Informal document: GRSG-126-29

“ACCESSIBILITY OF BUSES” **Draft Amendment of** **Regulation No. 107 for UN** proposition d’amendement du règlement 107

PROPOSED AMENDMENT TO ANNEX 8 OF
REGULATION NO. 107, WITH IMPROVEMENTS TO
THE UNIVERSAL ACCESSIBILITY OF BUSES.

Figure 21

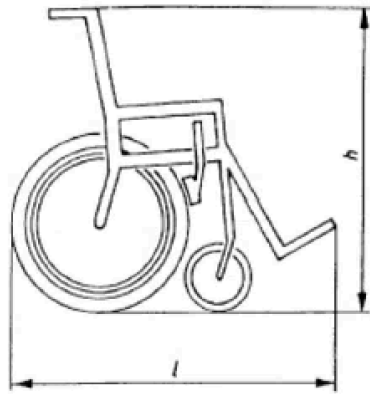
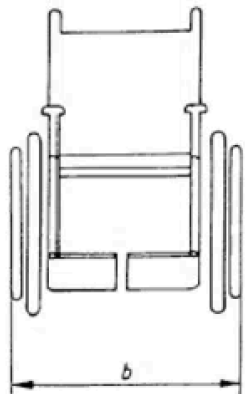
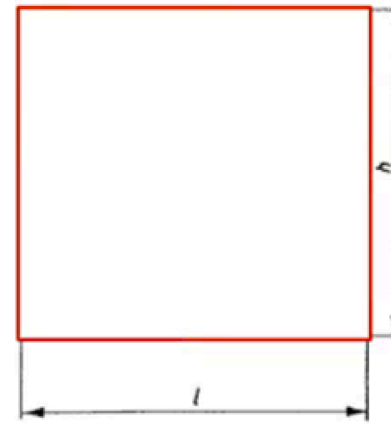
WHERE IT SAYS:

Reference wheelchair

WHERE IT SAYS:

IT SHOULD SAY:

Mobility support device reference volume

(see Annex 8, paragraph 3.6.4)

IT SHOULD SAY:

Overall length, l: 1 200 mm

Overall width, b: 700 mm

Overall height, h: 1 090 mm
